RENESAS TECHNICAL UPDATE

Product Category	MPU/MCU		Document No.	TN-V85-A003A/E	Rev.	1.00
Title	V850ES/Kx1, Kx1+ Restriction notification of Mask ROM products		Information Category	Technical Notification		
Applicable Product	V850ES/KF1 μPD703211 V850ES/KG1 μPD703215, πPD703215Y V850ES/KG1+ μPD703313, μPD703313Y	Lot No. All lot	Reference Document	-V850ES/KF1 User's manual : Hardware (U16891E) -V850ES/KG1 User's manual: Hardware (U16890E) -V850ES/KG1+ User's manual: Hardware (U16894E) -V850ES User's manual For Architecture (U15943E)

(Example) The pipeline disordered is generated by Alignment hazard:

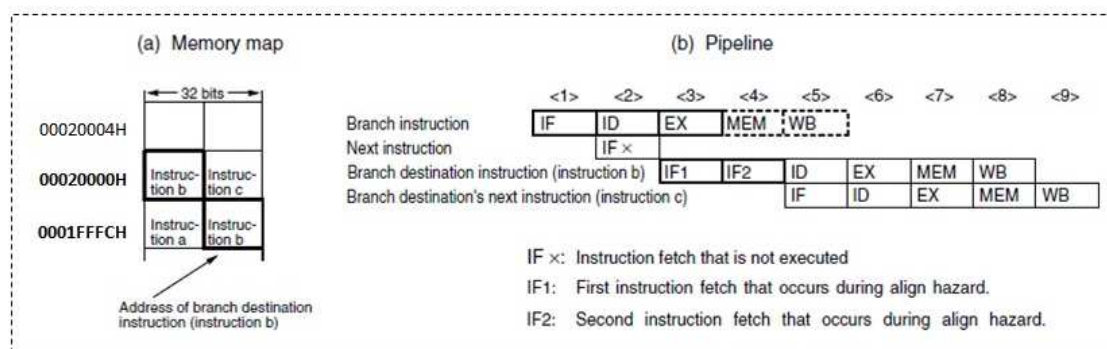
In the case of Applicable Usage, CPU executes the wrong instruction code.

In this case, the instruction b will not be executed correctly. And wrong instruction code is executed.
